United States Patent and Trademark Office

APPLICATION NO.	FILING DATE	FIRST NAMED INVENTOR	ATTORNEY DOCKET NO.	CONFIRMATION NO.	
10/766,391	01/28/2004	Douglas Dombrowski	DP-311282	3331	
22851	7590 10/06/2005			XAMINER	
DELPHI TECHNOLOGIES, INC.		LUONG, VINH			
M/C 480-410-2	202		DADED WITH CHES		
PO BOX 5052			ART UNIT	PAPER NUMBER	
TROY, MI 4	8007		3682

Application No.	Applicant(s)				
Office Action Summary		10/766,391		DOMBROWSKI ET AL.			
		Examiner	Art Unit				
		Vinh T. Luong	3682				
The MAILING DATE of this communication appears on the cover sheet with the correspondence address Period for Reply							
A SHORTENED STATUTORY PERIOD FOR REPLY IS SET TO EXPIRE 3 MONTH(S) OR THIRTY (30) DAYS, WHICHEVER IS LONGER, FROM THE MAILING DATE OF THIS COMMUNICATION. - Extensions of time may be available under the provisions of 37 CFR 1.136(a). In no event, however, may a reply be timely filed after SIX (6) MONTHS from the mailing date of this communication. - If NO period for reply is specified above, the maximum statutory period will apply and will expire SIX (6) MONTHS from the mailing date of this communication. - Failure to reply within the set or extended period for reply will, by

ATTACHMENT

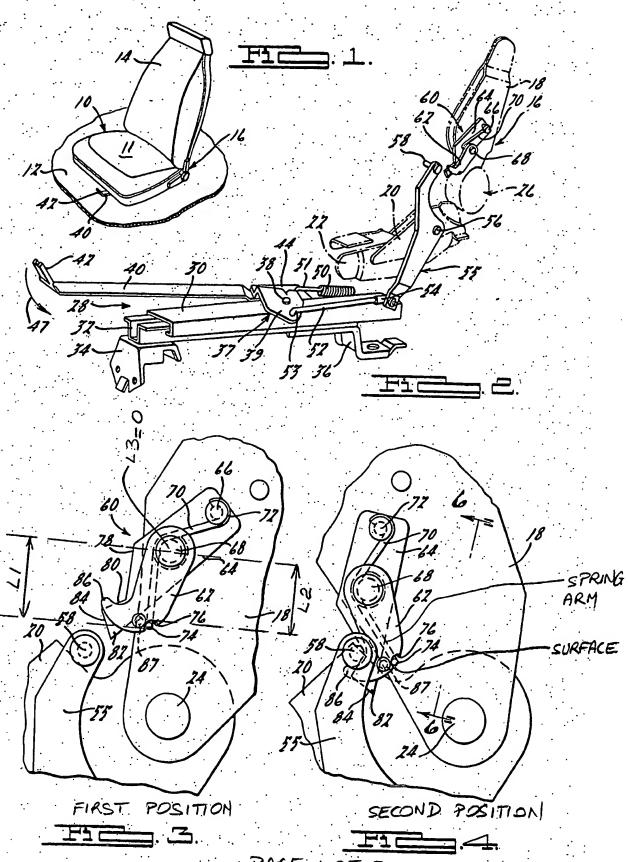
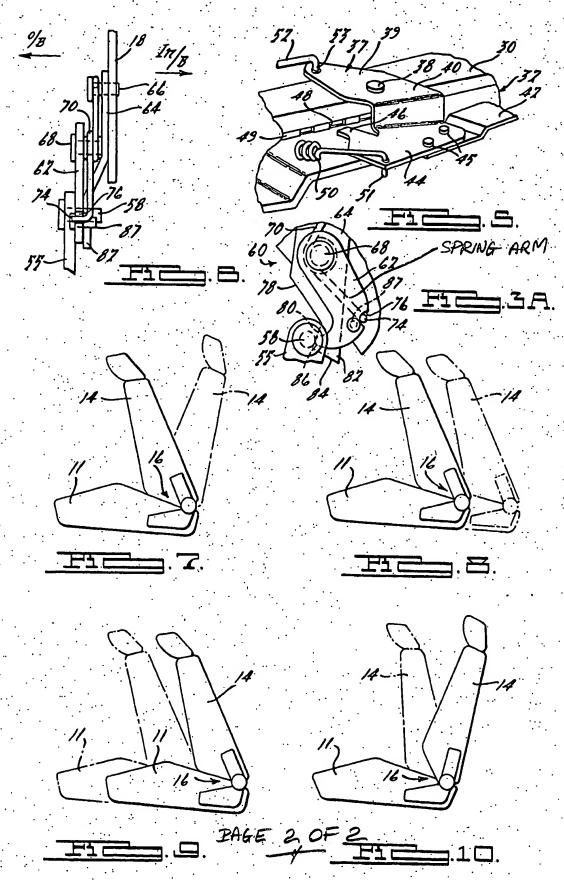
Regarding claim 1, Heling teaches a two position, spring biased lever system comprising a lever 62 that pivots on a support 68 between a first position (Fig. 3 or 3A) and a second position (Fig. 4), and a spring 70 having an arm (unnumbered. See Attachment) that engages the lever 62 to hold the lever 62 in the first position and concurrently biases the lever 62 toward the second position.

Regarding claim 2, Heling teaches a two position, spring biased lever system comprising a lever 62 that pivots on a support 68 between a first position (Fig. 3 or 3A) and a second position (Fig. 4), said lever 62 comprising a notch 76, and a spring 70 having a spring arm (Att.) that engages the notch 76 in the lever 62 to hold the lever 62 in the first position while biasing the lever 62 toward the second position when the lever 62 is in the first position.

Regarding claim 3, Heling teaches a two position spring biased lever system comprising a lever 62 that pivots on a support 68 between a first position (Fig. 3 or 3A) and a second position (Fig. 4), said lever 62 having a notch 76, and a torsion spring 70 having a tangential spring arm (Att.) that is attached to a central coil (at 68 in Fig. 3) at one end and that has a distal

end 74 engaged in a notch 76 of the lever 62, the torsion spring 70 being stressed so that the spring arm (Att.) holds the lever 62 in the first position when the distal end 74 is in the notch 76 while biasing the lever 62 toward the second position, the spring arm (Att.) moving the lever 62 to the second position when the distal end 74 is *partially* disengaged from the notch 76 (Fig. 4).

Regarding claim 4, the distal end 74 of the spring arm (Att.) when *partially* released from the notch 76 slides along a surface (Att.) of the lever 62 to bias the lever 62 to the second position.

Regarding claim 5, the distal end 74 of the spring arm 70 is a *substantially* perpendicular end portion of the spring arm (Att.), which when *partially* released from the notch 76 slides along a surface (Att.) of the lever 62 to bias the lever 62 to the second position.

Regarding claims 6 and 7, the spring arm (Att.) has a length L-1 (Att.) measured from its pivot to the distal end, wherein the lever has a length L-2 (Att. 2) measured from its pivot to the notch, and wherein the system has a length L-3 measured from the pivot of the spring arm to the pivot of the lever (L-3 = 0 because the pivot of the spring arm coincides with the pivot of the
